# Iowa Department of Transportation

## MINUTES OF IOWA D.O.T. SPECIFICATION COMMITTEE MEETING

April 12, 2012

REVISION	3	10-16-12
	<b>RM-48</b> SHEET 2 of 2		
<b>STANDARD ROAD PLAN</b> REVISIONS: Added Sheet 2 to include trailer mounted LED floodlights.			
APPROVED BY <i>Deanne M. Smith</i> DESIGN METHODS ENGINEER			
TEMPORARY FLOODLIGHTING

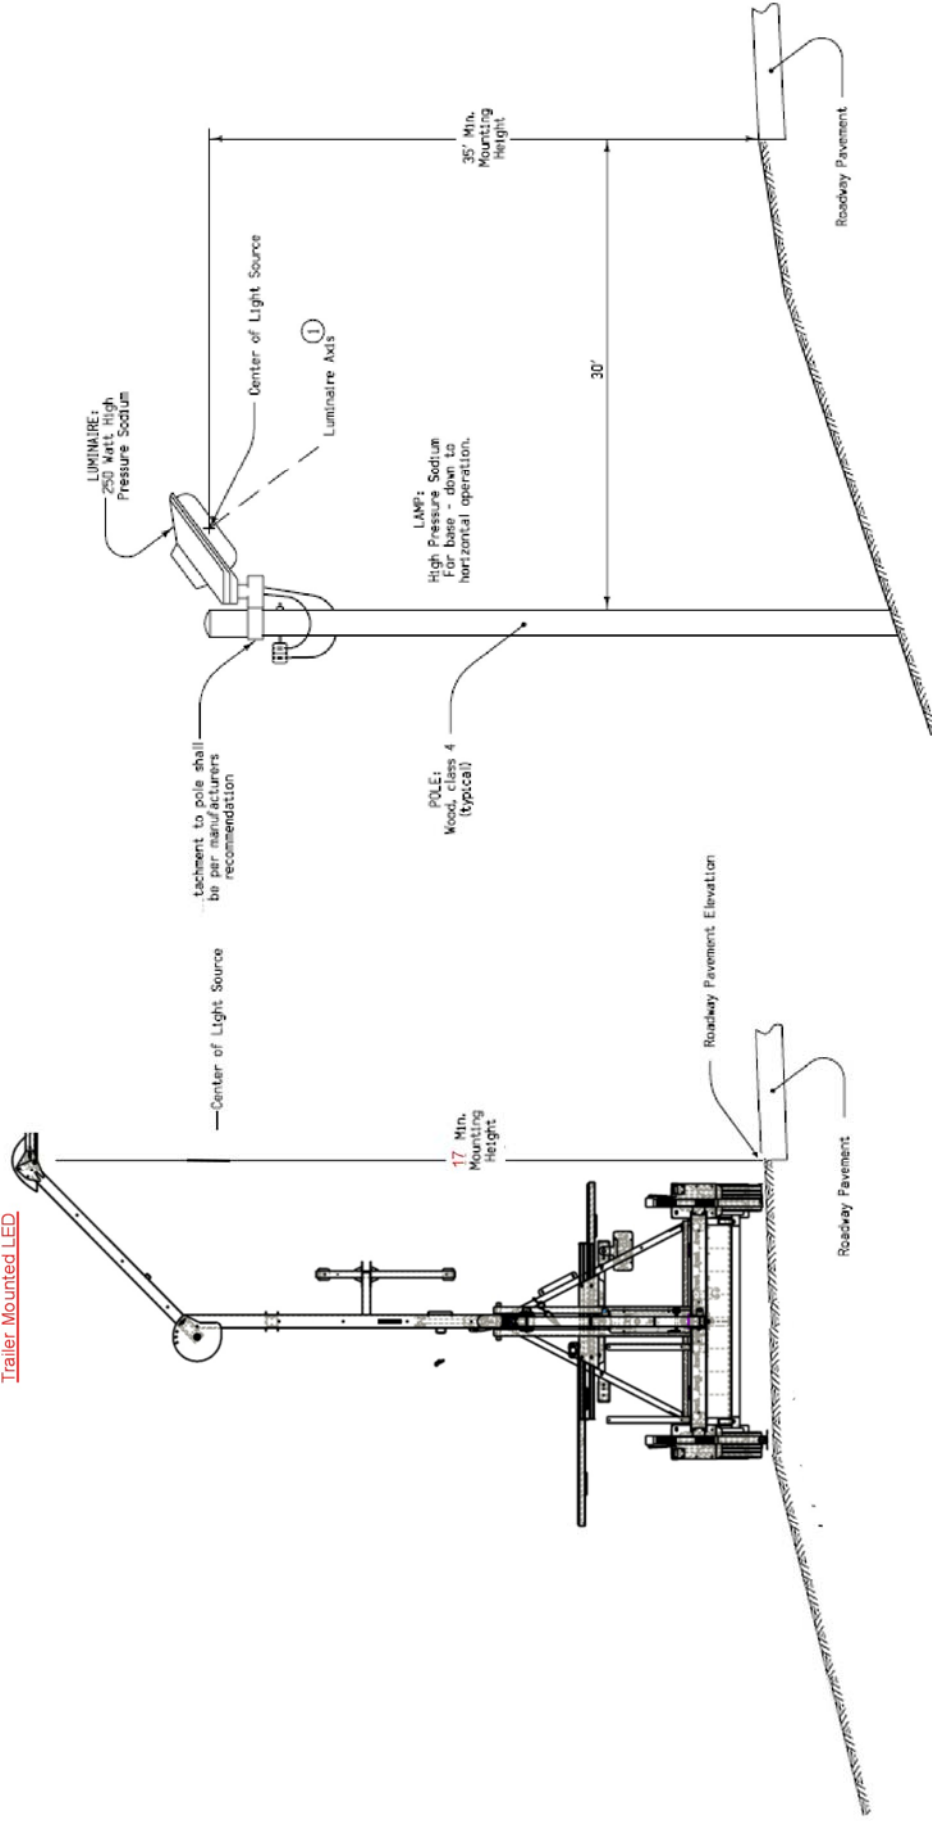
<p><b>Reason for Revision:</b> To update temporary floodlights to allow the use of Portable, Mobile Self Contained LED Floodlights. This change will mitigate some of the issues with having a licensed electrician for any temporary hardwired connections to existing power lines and the oftentimes remote locations that need hardwired lighting requiring conduits to be run for up to many miles to obtain a power source. In addition, these would be "green" power to mitigate any need for external power sources. RM-48, Temporary Floodlighting Standard Road Plan is being revised in conjunction with this specification change and will be effective with the October 2012 letting. A draft Materials IM 488.06 is attached.</p>					
<b>County or City Input Needed (X one)</b>			<b>Yes</b>	<b>No X</b>	
<b>Comments:</b>					
<b>Industry Input Needed (X one)</b>			<b>Yes</b>	<b>No X</b>	
<b>Industry Notified:</b>	<b>Yes</b>	<b>No</b>	<b>Industry Concurrence:</b>	<b>Yes</b>	<b>No</b>
